# UNITED STATES PATENT AND TRADEMARK OFFICE

APPLICATION NO.	FILING DATE	FIRST NAMED INVENTOR	ATTORNEY DOCKET NO.	CONFIRMATION NO.
10/528,502	08/01/2005	Thomas Dörner	54651/DBP/M521	4395

<b>Office Action Summary</b>	<b>Application No.</b> 10/528,502	<b>Applicant(s)</b> DORNER, THOMAS	
	<b>Examiner</b> David R. Crowe	<b>Art Unit</b> 2885

### **DETAILED ACTION**

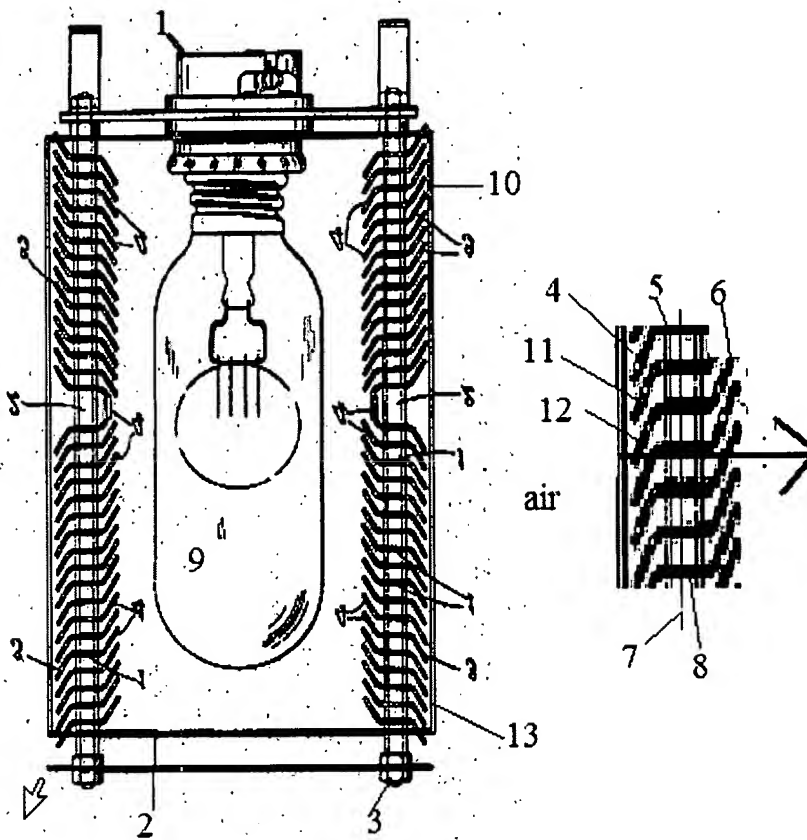
Re claims 1 and 16: McCormack discloses (see below) a spotlight for cinema with a light source [9]; a spotlight housing surrounding the light source with lower part [2] comprising at least one side wall [3], and an upper part [top half], including a transparent cover [inherent to receiving light from the source]; and a ventilation shaft [10] mounted on at least one side wall [3] wherein the shaft comprises: an air inlet aperture [plane of shaft 10], an air outlet aperture defined along a plane [7] and a plurality of ribs [12] defining a plurality of ventilation ducts [11] there between, wherein each rib comprises a first rib section [4] extending to the air inlet aperture, a second rib section [5] extending to the air outlet aperture and bent relative to first section [4]. The ribs further comprising air guide sections [8] extending from the air outlet aperture and projecting beyond the air output aperture. The bottom rib is the first rib and a second rib is defined as the rib above the first rib [to provide definition in the claim not patentable structure] where the first rib has an air guide section [8] that projects entirely perpendicular from the plane of the air outlet aperture and the second rib has an air guide section [8] that projects entirely at an angle relative to the plane of the air outlet aperture in a direction away from the plane. [The claim fails to provide sufficient limitation to the location of the inlet and outlet. Therefore under the broadest reasonable interpretation of the examiner, the inlet is defined as at the bend of rib

portions 4 and 5, therefore allowing the first portion 4 to extend to i.e. approach the inlet. The outlet aperture plane is then defined as the plane perpendicular to the second section 5 and dividing second section 5 from guide section 8 therefore allowing the second section to "extend to" or approach the outlet aperture. Guide portions 8 are then perpendicular to the outlet plane. Guide portions 8 are similarly at an angle of 90 degrees to the plane of the air outlet aperture. Lastly the guide portion 8 is interpreted as entirely perpendicular and entirely at an angle because the upturned portion 6 shown in the figure below can be viewed as its own item entirely in addition to the claimed features as allowed by the inclusive claim language.]

Re claim 3: McCormack discloses each second rib section [5] being horizontal.

Re Claim 5: McCormack discloses the inlet to the ventilation shaft at the leading edge of the first rib section [4] flush with housing body [13]. [The inlet aperture can be interpreted as the leading edge without disrupting the interpretation of claim 1 since "extending to" is shown not to mean "ending at", but can also be "being from" as long as a side of the first rib section is adjacent to the inlet aperture.]

Re claims 13 and 17: As discussed in claim 1 above, the second sections [5] extend perpendicularly relative to the plane of the air outlet aperture.

Re claim 2: Although McCormack fails to teach the angle of the guide portions changing relative to the distance from the base, where the guide portions are defined as section [8] alone in the figure above, it would have been obvious to one having ordinary skill in the art of cooling ventilation to adjust the guide portions to direct the cool air onto the light source as necessitated by the lamp structure. It would have been obvious that varying the angles could distribute the cooling area over a larger area of heated surface and therefore improve cooling efficiency.

Re claims 14 and 18: Although McCormack fails to teach the second rib portions [5] extending away from the base because they are parallel with the base in the figures provided, it would have been obvious to one having ordinary skill in the art at the time the invention was made to configure the ribs to maximize air flow while maintaining blockage of light. The claimed configuration lacks criticality required to make the feature patentable over the prior art as the applicant has given a variety of shaft and duct configurations with appear in the specification to be designed specifically based on their location relative to the light source and therefore the housing. However the claims

However, the examiner interprets McCormack's perpendicular portion alone is sufficient to read as an air guide and therefore that portion is entirely perpendicular. The portion that extends at an angle referred to by the applicant can be reasonably be interpreted as its own separate portion which is in addition to the claimed portions. The claim language/open transitional phrase, "comprising" is inclusive and therefore allows for additional portions not included in the claim. The limitation "perpendicularly" in claim 1, line 19 is defined to form a right angle, 90 degrees. Therefore, the perpendicular air guide is "at an angle," of 90 degrees, relative to the outlet aperture plane.
